MAYFLOWER PLATINUM

Details of Additions & Alterations

Flat No	805	Block no.	'B'
Flat Area	1800 sft	Type	Deluxe / Luxury
Buyer Name	Thota Anila Kiran		
Phone No.	8897387243/9959224411/ 9440000599(w)	Email	suryakiranthota@gmail.com

Description	Direction	Owners & Developers :	Date :	18.03.2020	Promoted by
WORKING DRAWING OF FLAT.NO.B-5		Modi Properties Pvt Ltd.	Prepared By :		
		Project Name & Phase :	Approved By :	Soham Modi	Modi Properties Pvt. Ltd
		MAYFLOWR PLATINUM	Scale :	N.T.S	Phone:+91-40-66335551

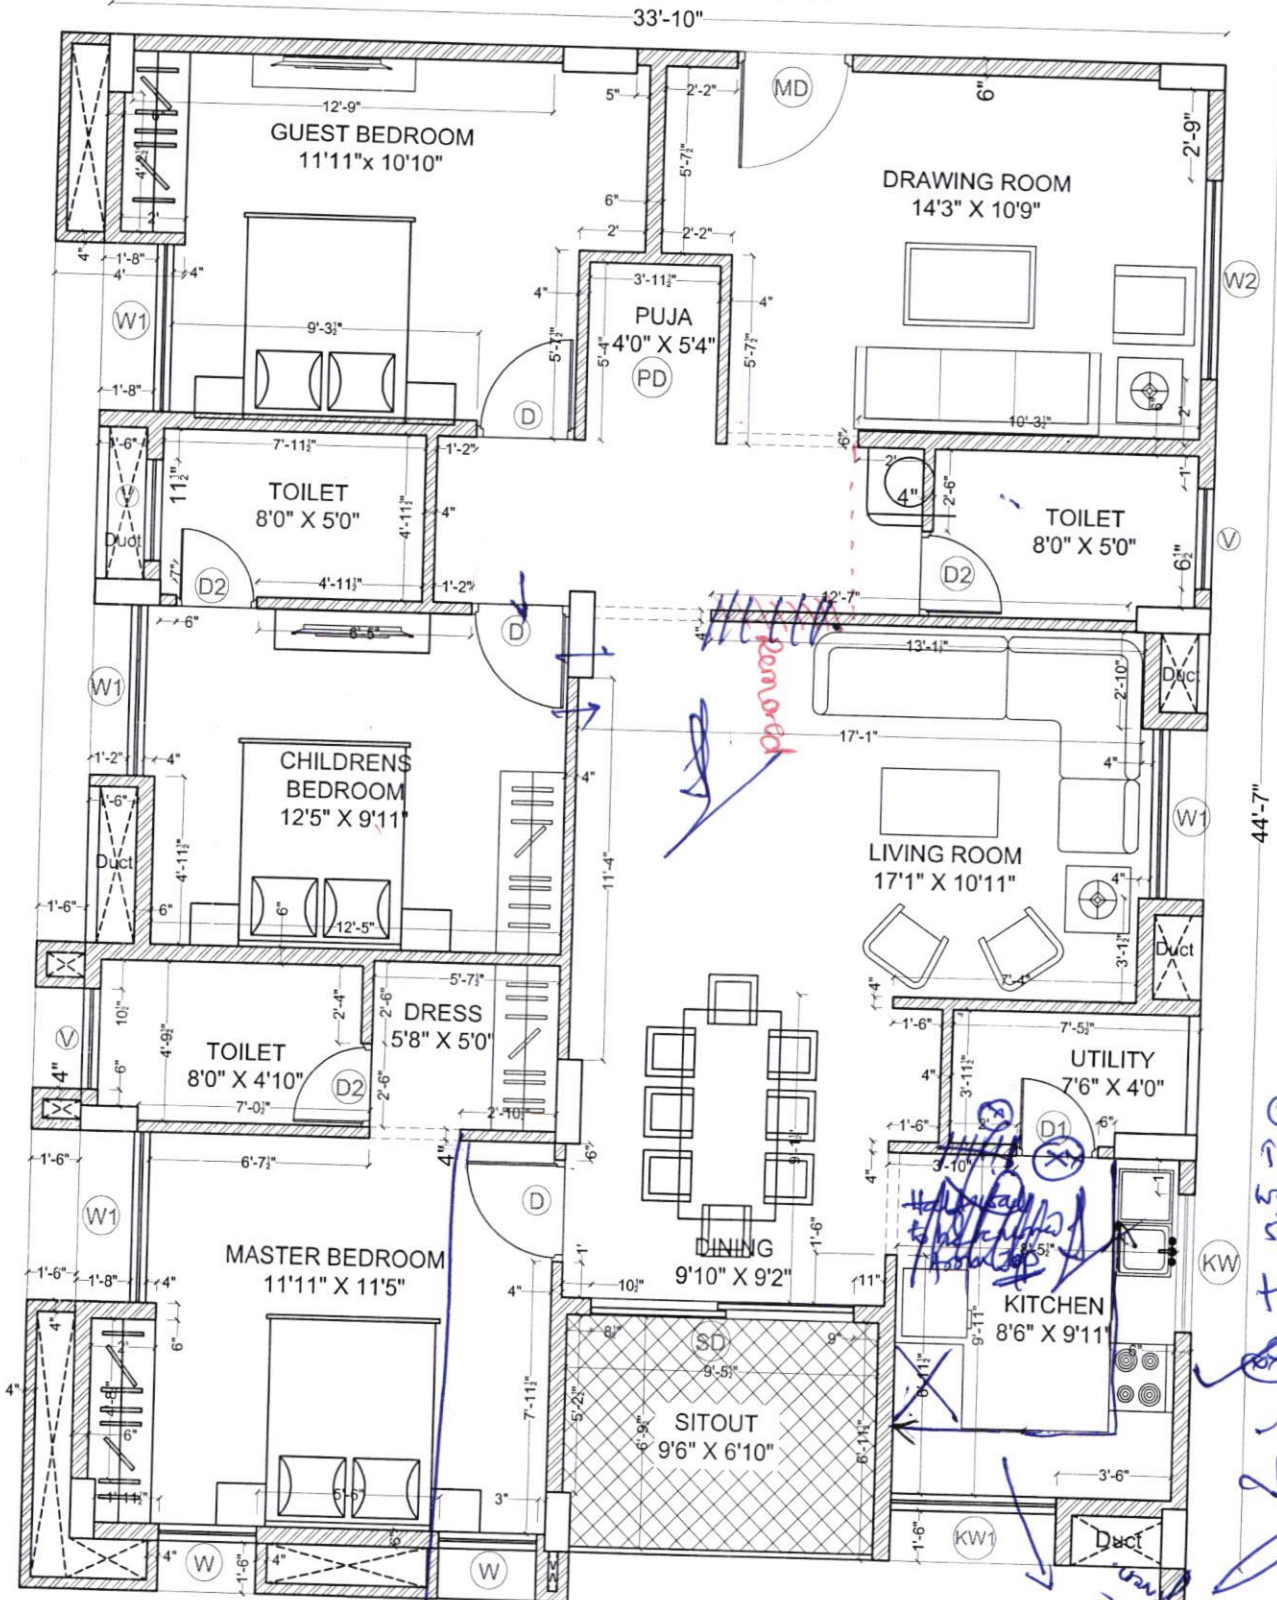
1. ~~Wall in the front hall (near sink).~~
~~It will be.~~
2. open utility room (Door not
only frame to be given. ^{marked on plan} ~~replaced~~)
3. Wash basin @ common bath
not in the hall marked on plan
4. Wall to be reduced to toilet wall
in drawing & living area marked on plan

↓ wall to be exactly to door level.

⊗ No build wall with 5'6" from floor level
⊗ No door
⊗ Team will be there

ELECTRICAL PLAN OF FLAT-B5

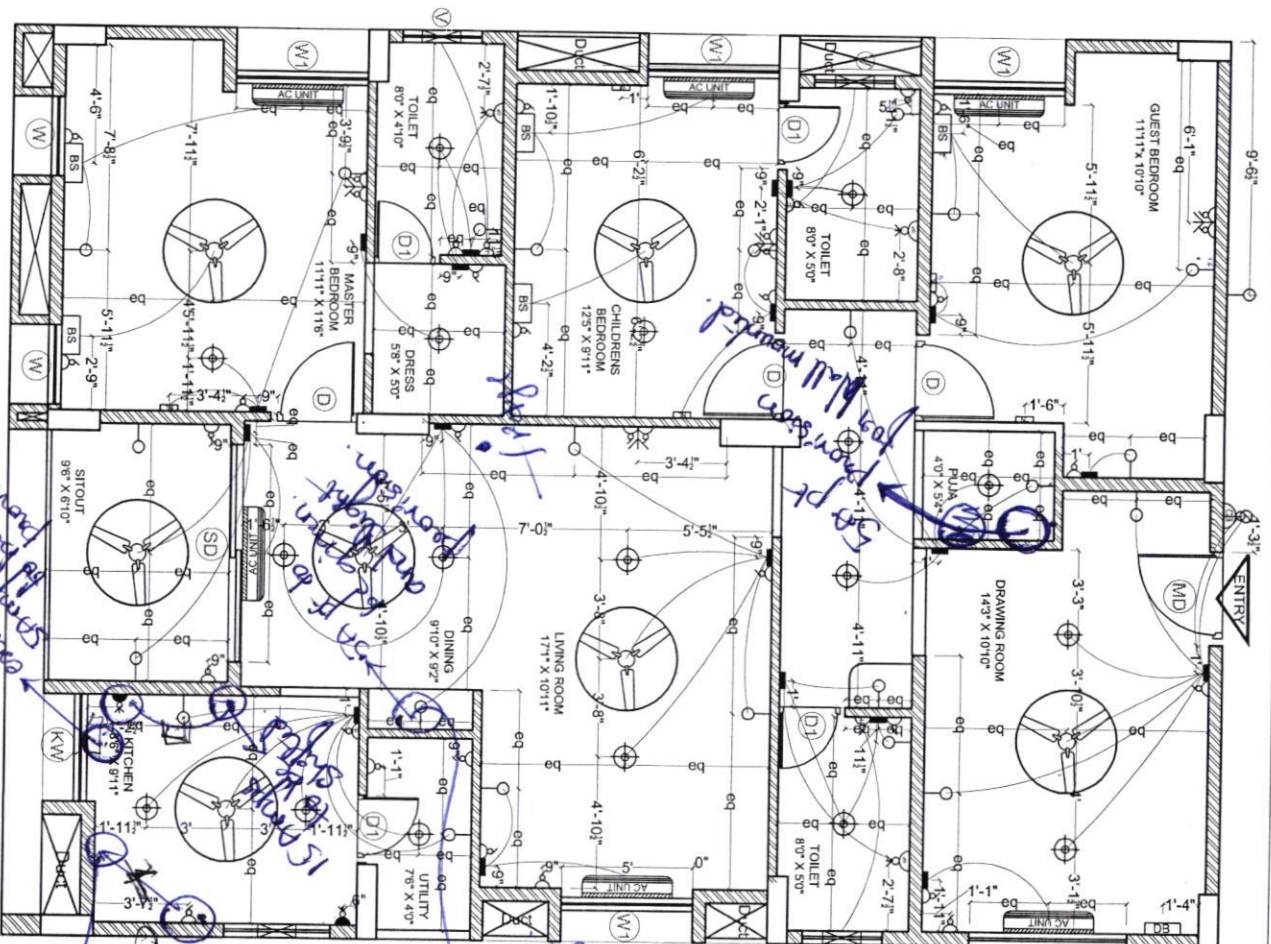
Same as spec'd.
plus 1

Exhaust points provision in 3 toilets &
kitchen suitable size for the room (medium
size)

PLUMBING PLAN OF B5

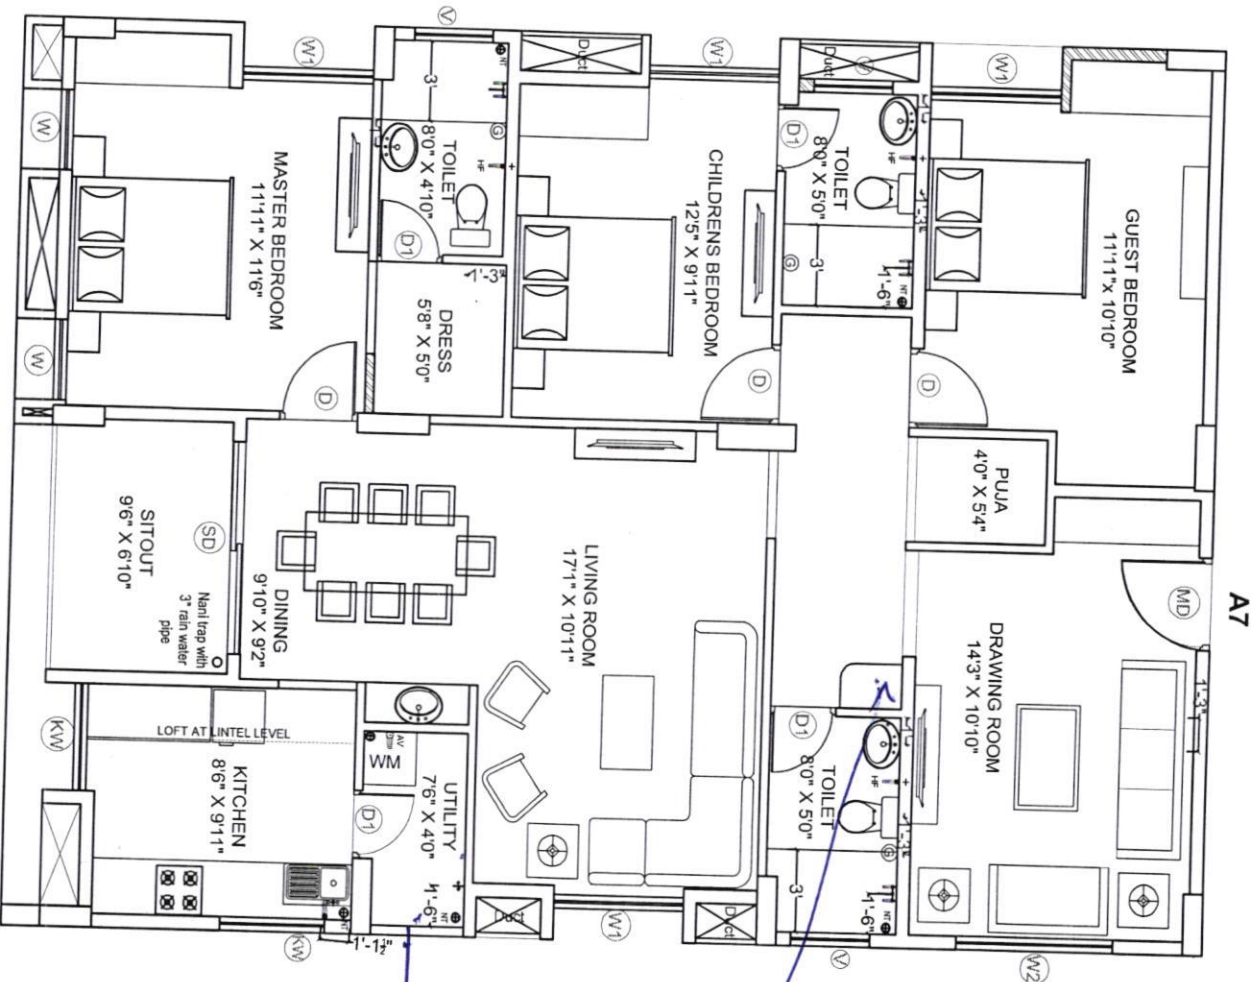
WB provision
